Tower_HRSC_CSM_SoilVolumetrics.4dm -slide 1- notes in red

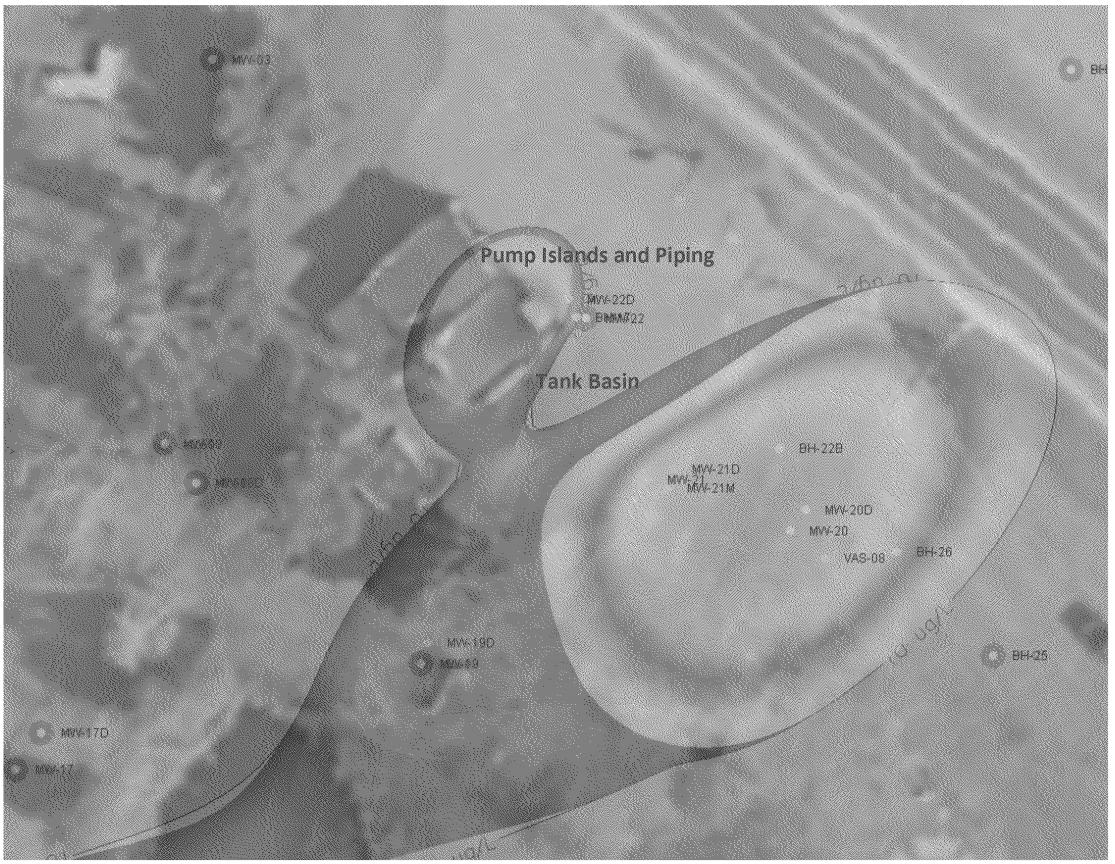
Tank Basin and Piping Excluded from Plume- Affects CSM- likely from data input errors
